ADDENDUM | No. 2

PROJECT	Alcester WWTF Improvements		
BID DATE	11:00 AM	Central Time Zone	June 28, 2022
BID LOCATION	Alcester City Hall 500 Dakota Street Alcester, SD 57001		
ISSUE DATE	June 24, 2022		
NOTICE	Failure to acknowledge all addenda in the BID may cause rejection of the BID. See Instructions to Bidders.

Drawing Sheet 3D-800

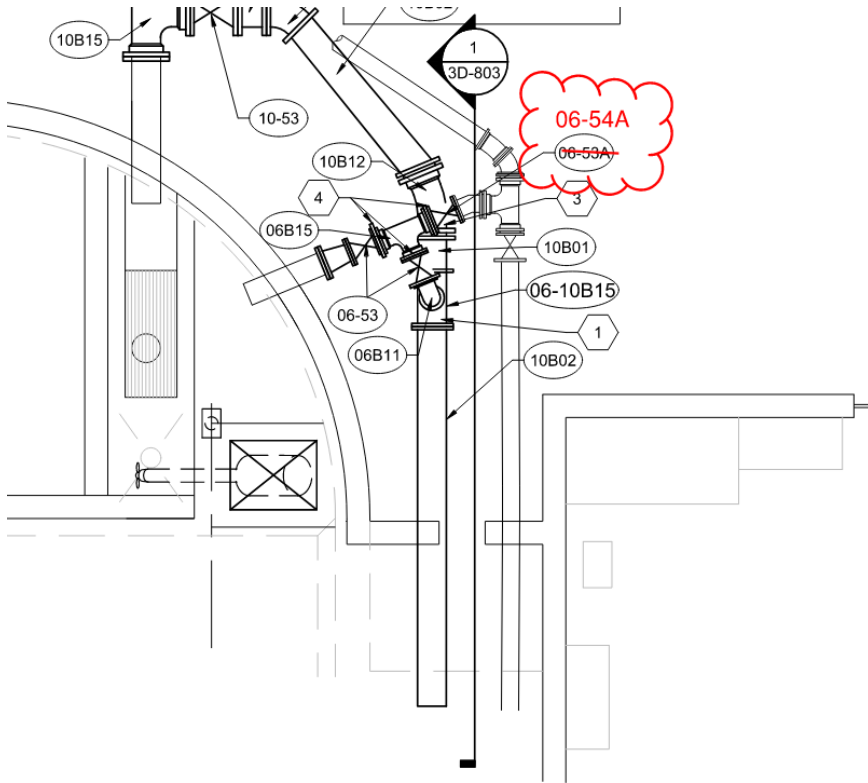
Add note to indicate that the 'A' behind plug valve will indicate that it is actuated.

1 LAB 3A-102 EAST ELEVATION
3A-101 3/8" = 1'-0"

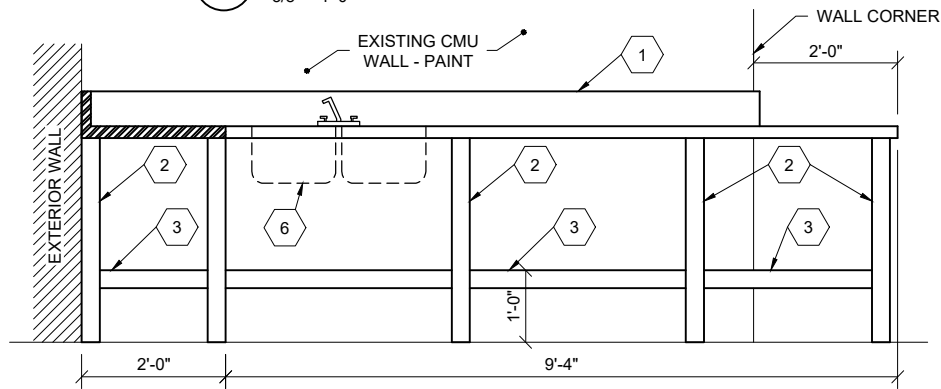
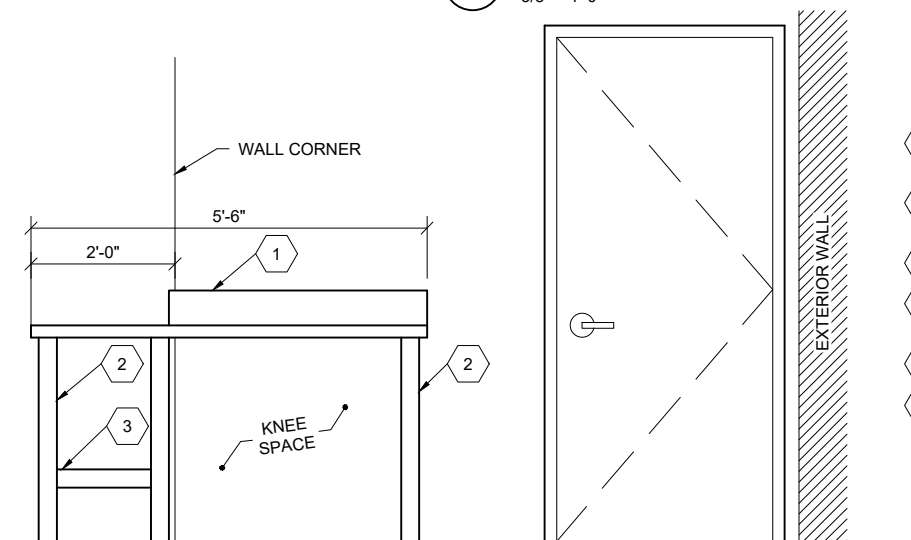
Lab Casework Interior Elevations. Refer to Attachment Figure 2-1.
